# SONY® Service Bulletin

NO: ME3-97-003

SUBJECT: PART NUMBER INFO: MOUNTING HARDWARE

MODEL (S): MDX-40

## MOUNTING HARDWARE

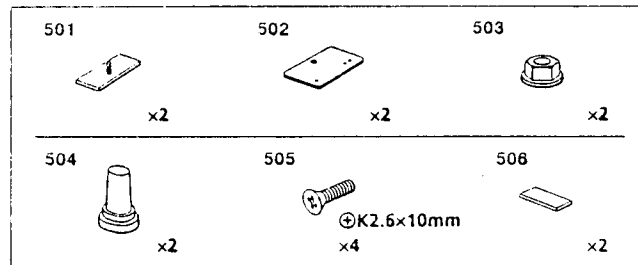
On page 36 of the Service Manual, part #501 and #502 are reversed. Please correct the Service Manual as follows: #501 corresponds to **Bracket Assy (X-3368-710-1)** and #502 corresponds to **Bracket Assy (A) (3-915-870-01)**.

<del>502</del>	<del>✗</del>	3-915-870-01 BRACKET (A)
<del>501</del>	<del>✗</del>	X-3368-710-1 BRACKET ASSY
503		4-304-511-00 NUT (M5), FLANGE
504		3-915-871-01 CAP
505		7-621-559-63 SCREW +K 2.6X10
506		3-913-873-01 CUSHION (COVER)
